SII 16 JAN 2016
PROPOSED
DESIGN NO. 15-0094
RED-IN YELLOW-OUT

REGION SOUTHERN
SUB. LEITHTON 332
CN
SIGNALS AND COMMUNICATIONS HOMEWOOD
DES.
CH.
SITUATION SKETCH
SCALE 1" = 20′
PLAINFIELD, IL
135TH ST
LEI-011. 44-0
DOT#260 575M
14

SII 17 JAN 2016
PROPOSED
DESIGN NO. 16-0003
RED-IN YELLOW-OUT
AS INSTALLED
DATE _____
BY _____
(PRINT NAME)

REGION SOUTHERN
SUB. LEITHTON 332
SIGNALS AND COMMUNICATIONS HOMEWOOD
10 JULY 2001
DES. BJH
CH. JJ
TRACK LAYOUT & INDEX
PLAINFIELD, IL
135TH ST
LEI-011.44-01
DOT#260 575M

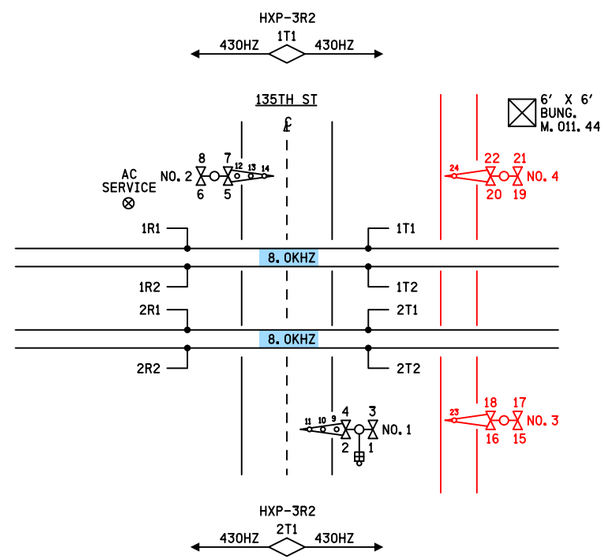
PHASE 1: INSTALL SEARII
PHASE 2: REMOVE HCA & CRTU

BATTERY BUS & RECTIFIER WIRING
PLAINFIELD, IL
135TH ST

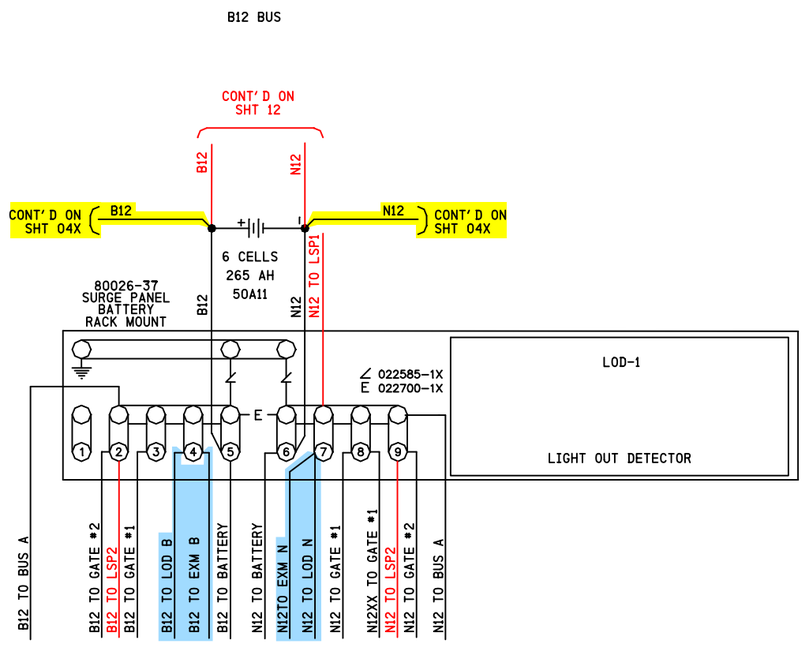
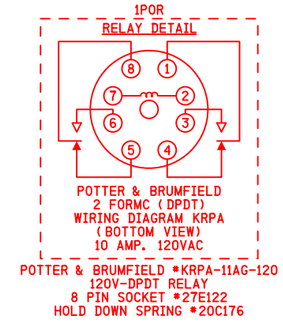
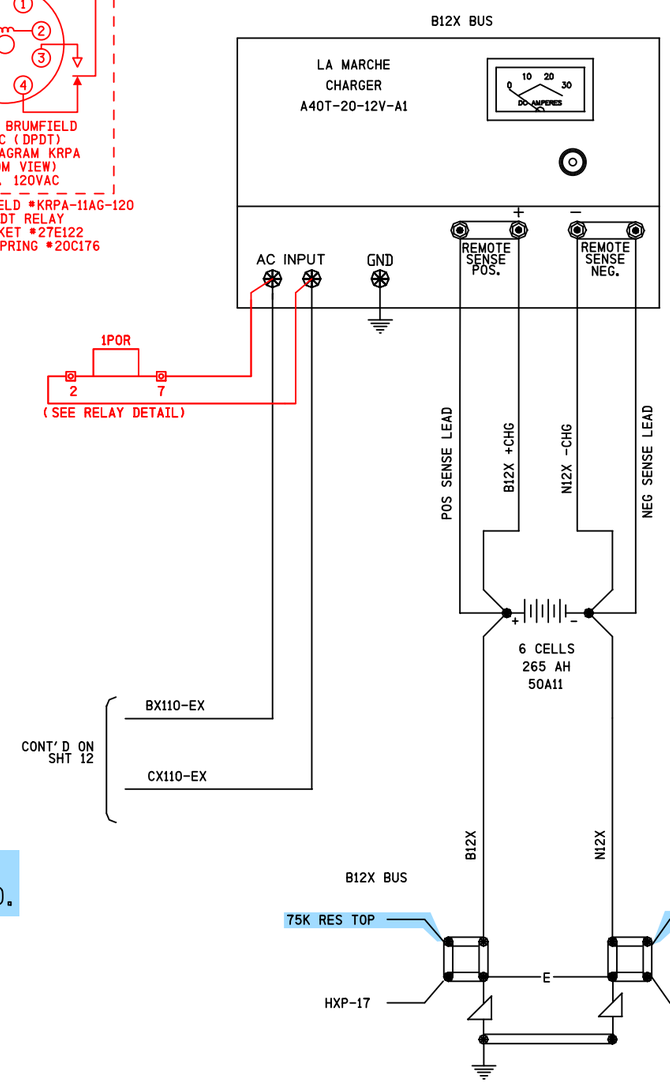
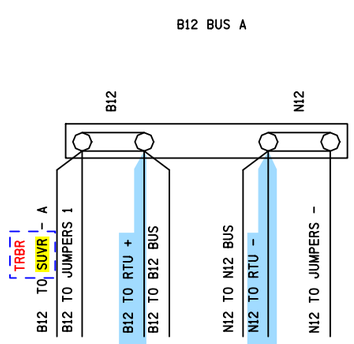
SEAR/RAILFUSION
PHASE 2: HCA AND CRTU WIRING TO BE REMOVED.

REGION SOUTHERN
SUB. LEITHTON 332
SIGNALS AND COMMUNICATIONS HOMEWOOD
10 JULY 2001
DES. BJH
CH. JJ
HIGHWAY CROSSING ANALYZER & LOD WIRING
PLAINFIELD, IL
135TH ST

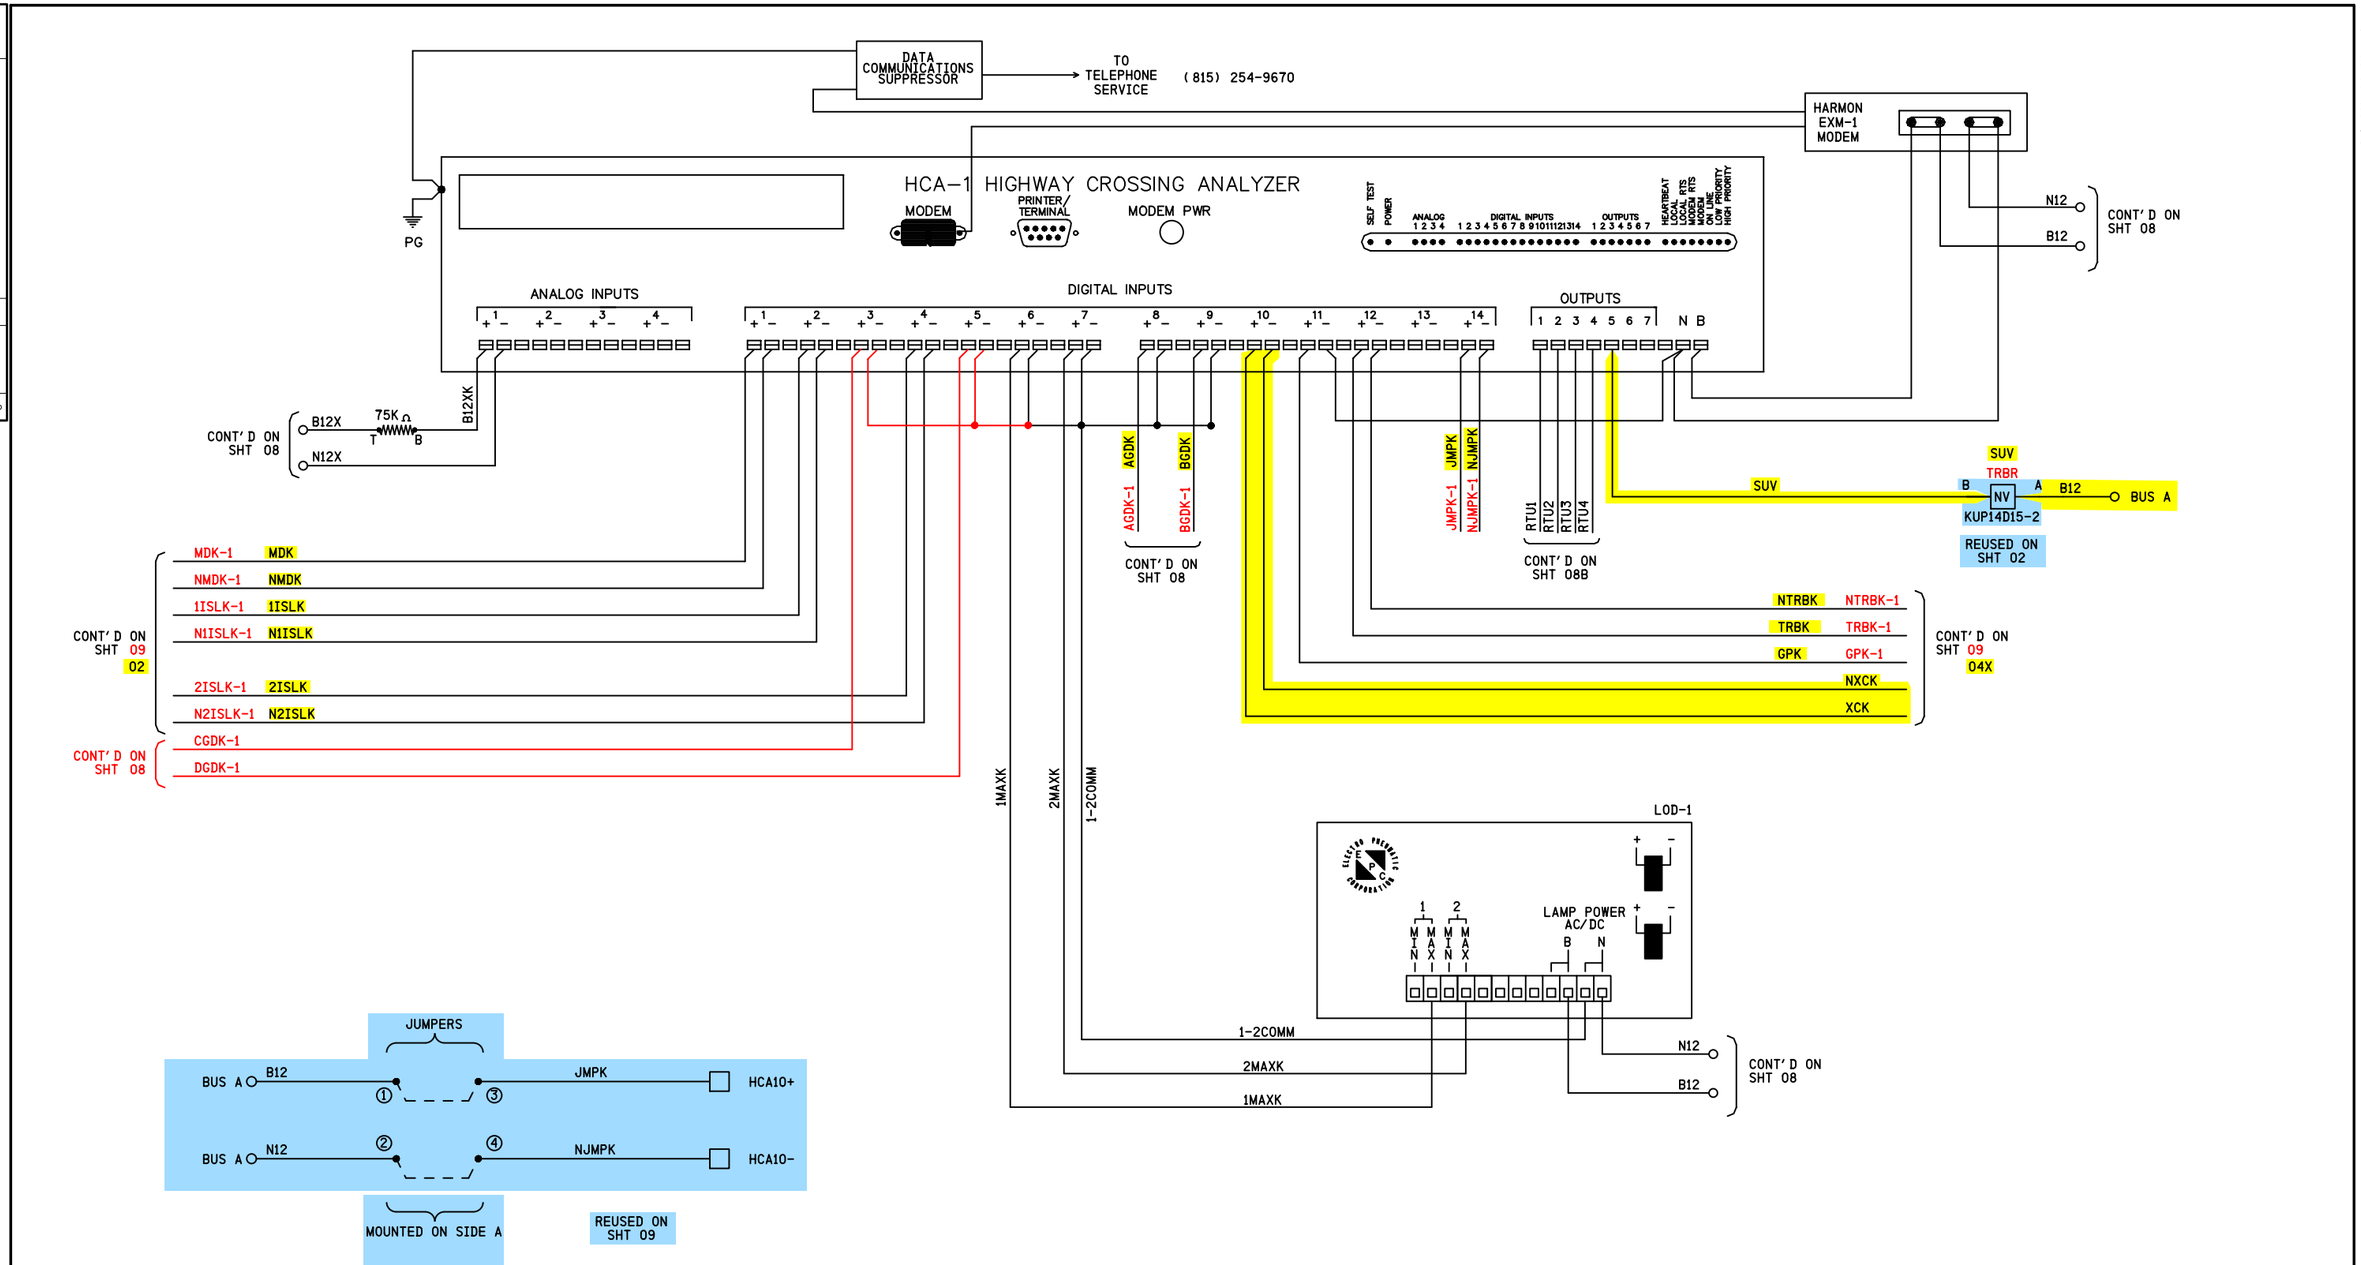
PHASE 1: WIRE AS SHOWN
PHASE 2: ALL HCA-1 EQUIPMENT AND WIRING TO BE REMOVED.

RTU UNIT & WIRING

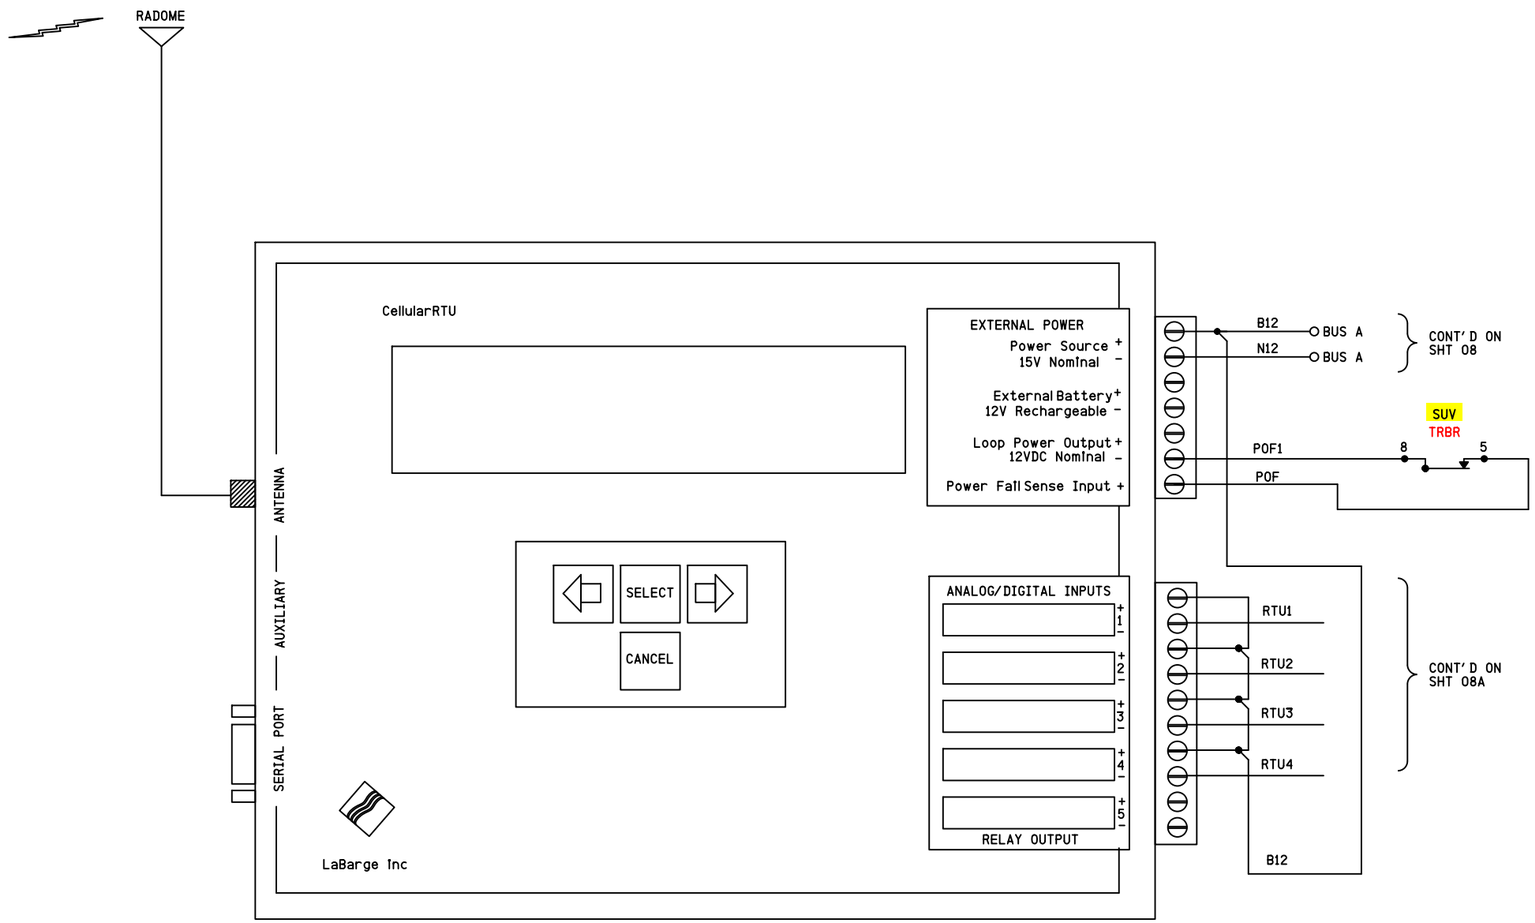
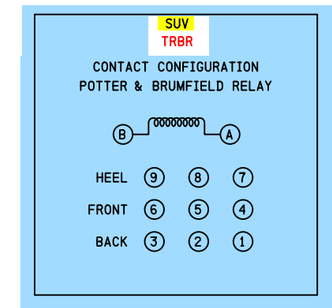
PHASE 1: CRTU TO REMAIN IN SERVICE
PHASE 2: ALL CRTU EQUIPMENT AND WIRING TO BE REMOVED.

SAFETRAN EVENT ANALYZER RECORDER II (SEAR II)
PLAINFIELD, IL
135TH ST

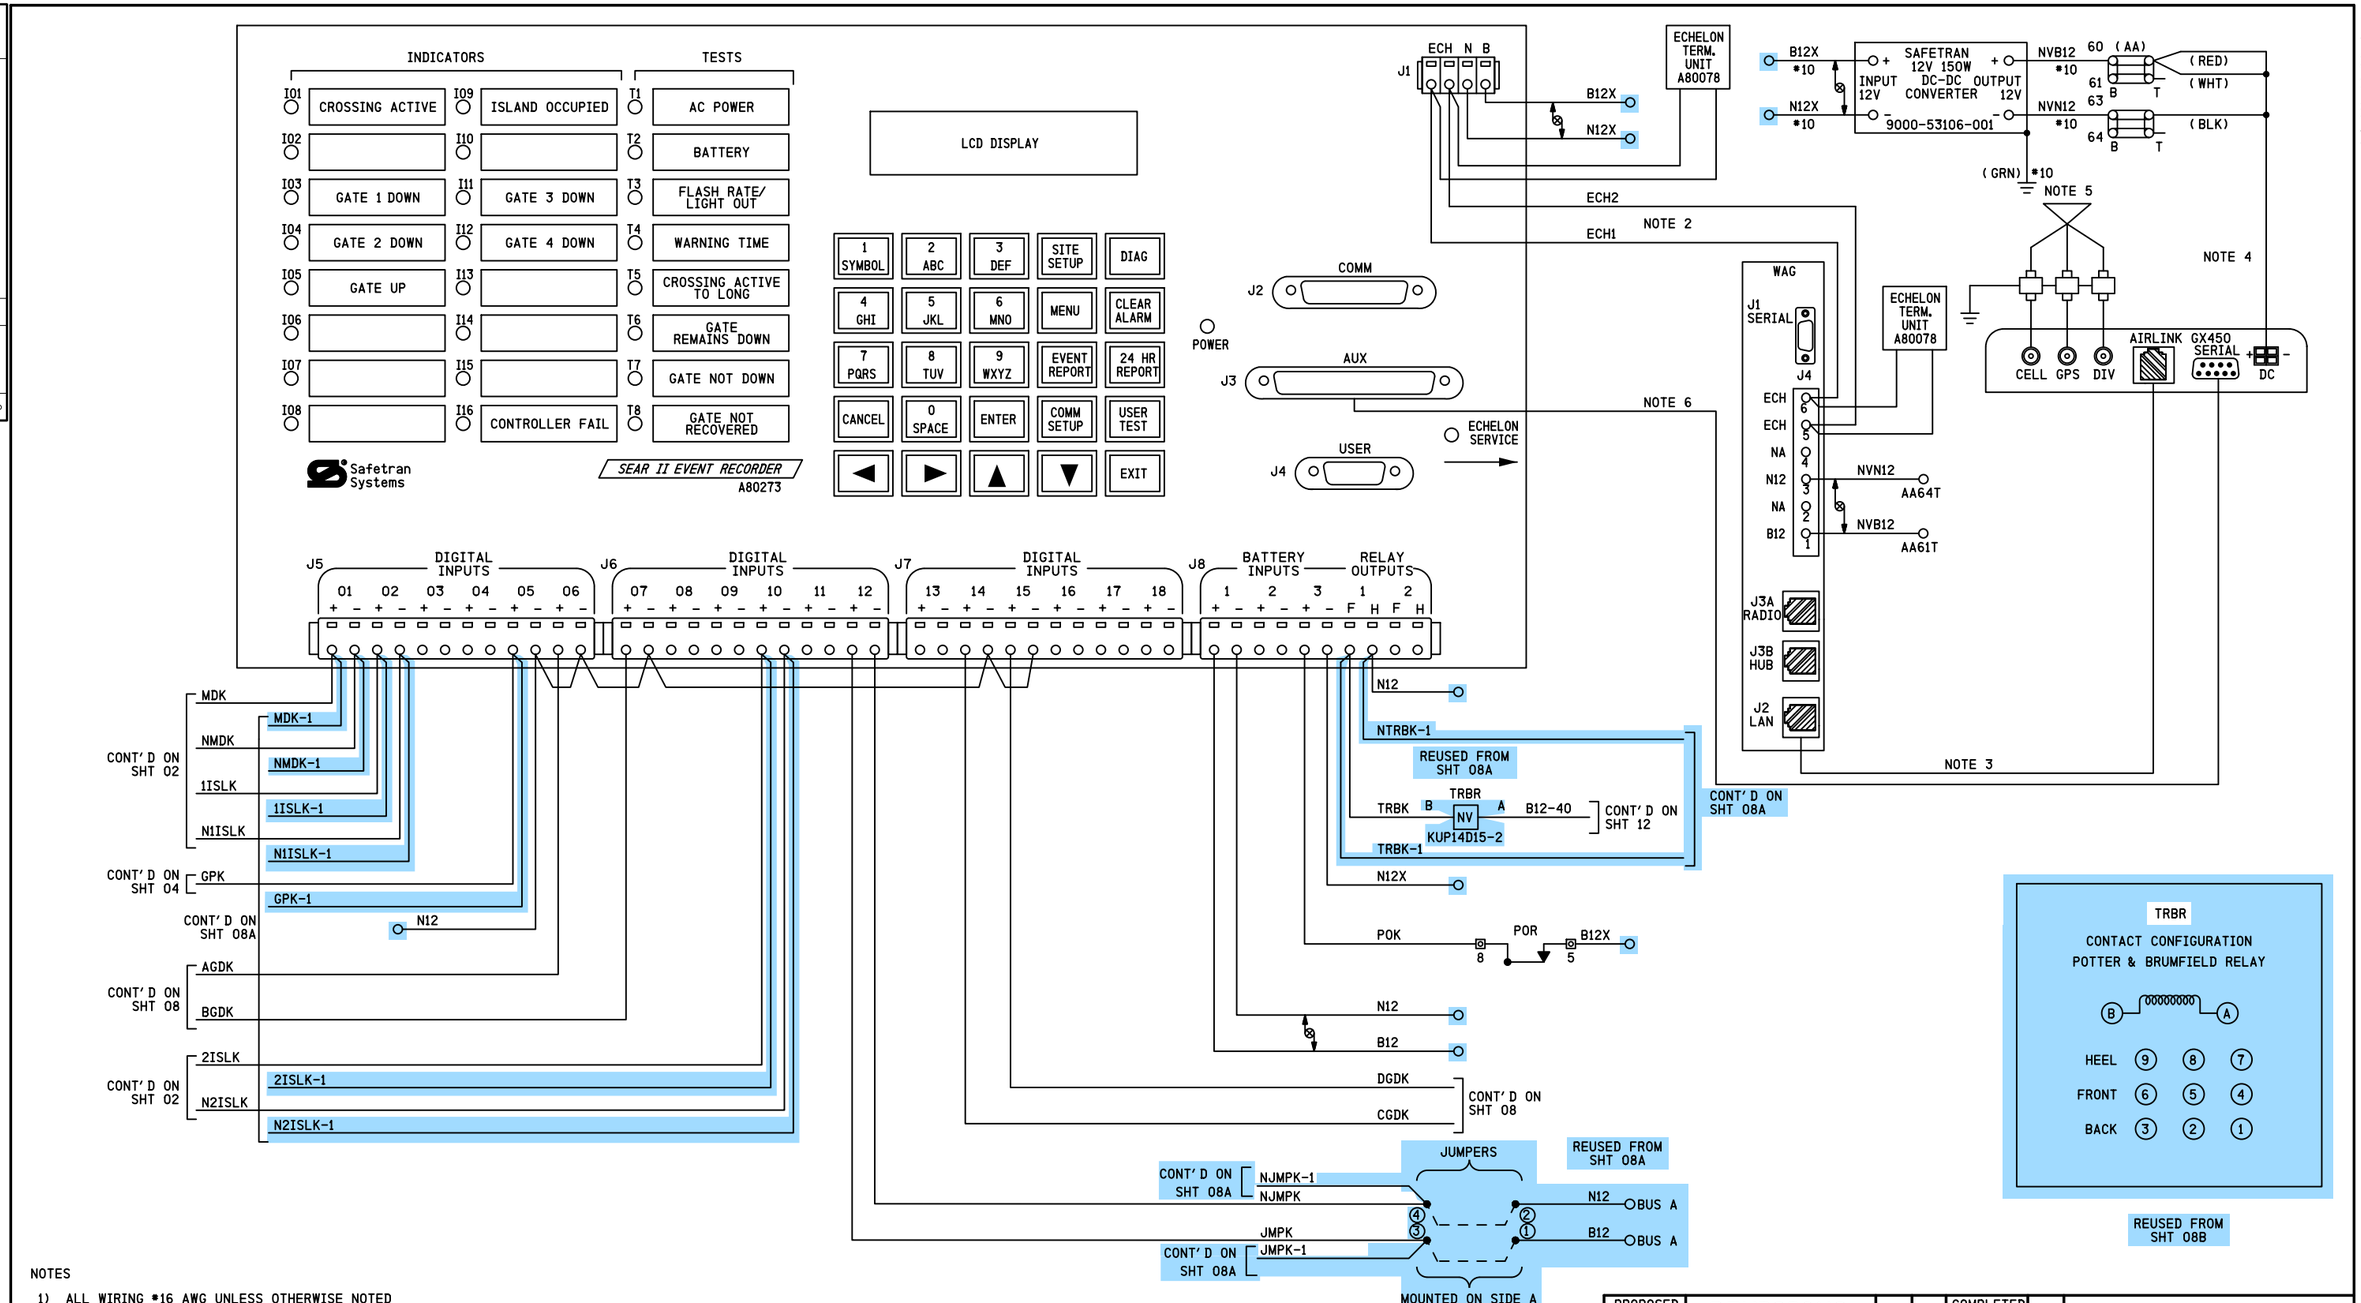
PHASE 1: TEMPORARY WIRING TO HCA AS SHOWN
PHASE 2: ALL WIRING TO HCA TO BE REMOVED.

FIELD TO VERIFY TERMINALS

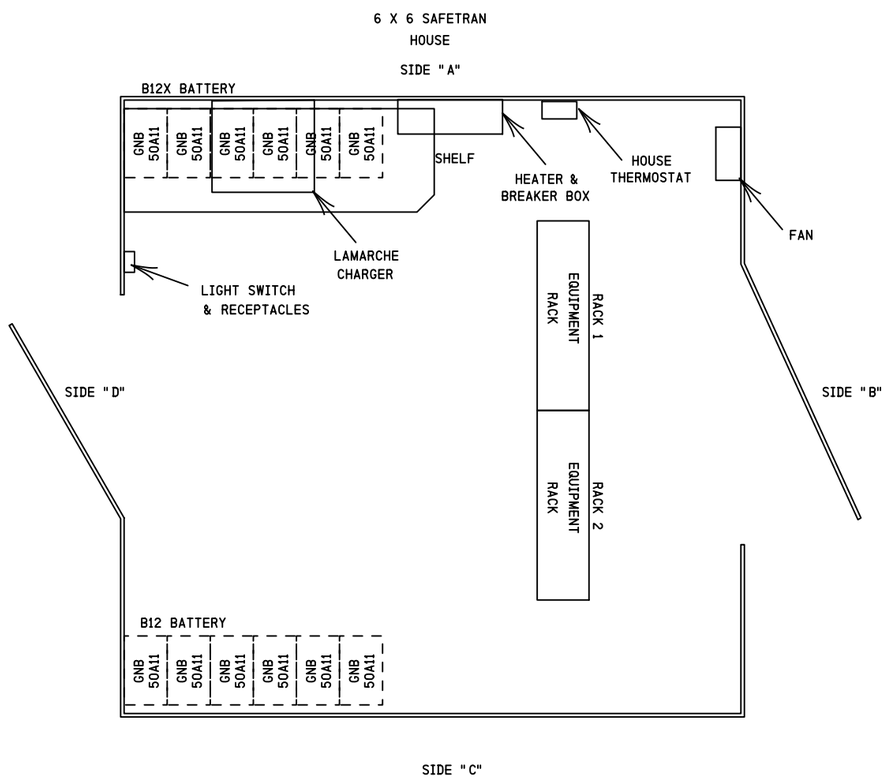
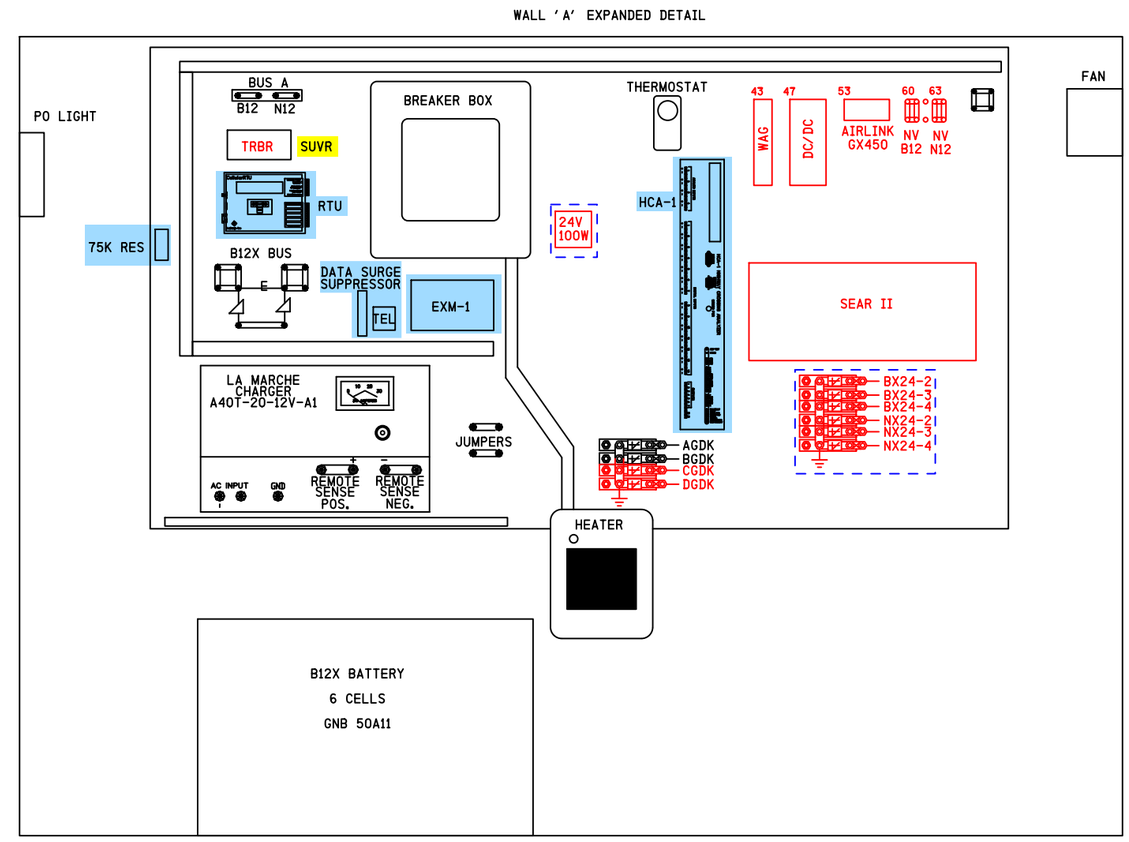
PHASE 1: SEAR/RAILFUSION INSTALLED
PHASE 2: ALL HCA AND CRTU EQUIPMENT AND WIRING TO BE REMOVED.
